Re: 2nd 70-GPM WesTech UF Skid w/3 Toray HFUG-2020AN Modules (PR#111-2023)

Detroit Water System (PWS ID#00257)

Final Approval

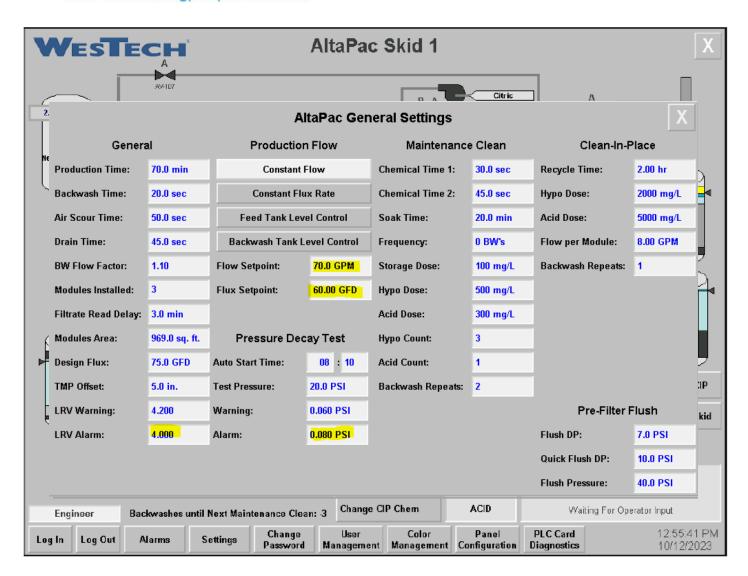
Note that $LRV_{ambient}$ values displayed in SCADA are indicated as " LRV_{DIT} " as shown below but should be displayed as " $LRV_{ambient}$ ". Please consider contacting WesTech to make this change in the SCADA system.

LRVambient is being calculated live and is visible on the HMI at any given moment. The operator can open the following screen when desired. The LRV equation contains both a live ALCR value and flow, and the most recent DIT pressure loss. The LRV in blue font is the LRVambient in the screenshot below.

- R. LRV alarm is set at 4.0 log
- R. The system is set to run at a set flow rate of 70 gpm. Toray recommended maximum flow rate is 66 gpm per module.

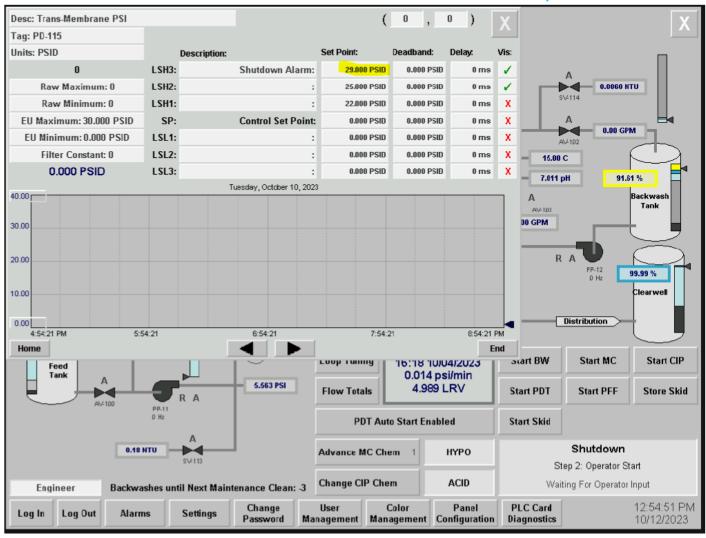
R. The Trans Membrane Pressure shutdown is set at 29 psi.

R. WesTech advises to take the membrane unit out of service and notify the Operator with a Shutdown Alarm if the IFE turbidity exceeds 0.15 NTU for more than 15 minutes. However, WesTech advises against triggering a DIT if the filter effluent turbidity is greater than 0.15 NTU for more than 15 minutes. In the past, WesTech has seen this trigger cause the system to be stuck in a loop because the high turbidity may not solely originate from damaged fibers. WesTech advises to trigger a system shutdown and have the operator go through several troubleshooting steps. Troubleshooting may require water quality testing, running a DIT, or others.

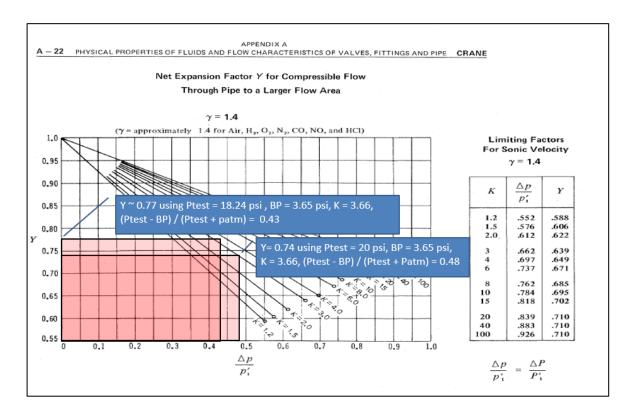
Using a lower net expansion factor yields a lower ALCR and LRV_{DIT}, therefore using Y = 74 as in the LRV calculations provided by WesTech is acceptable.

Using the appropriate chart on page A22 or A23 (CRANE - Flow of Fluids) yields a value for Y as shown below:
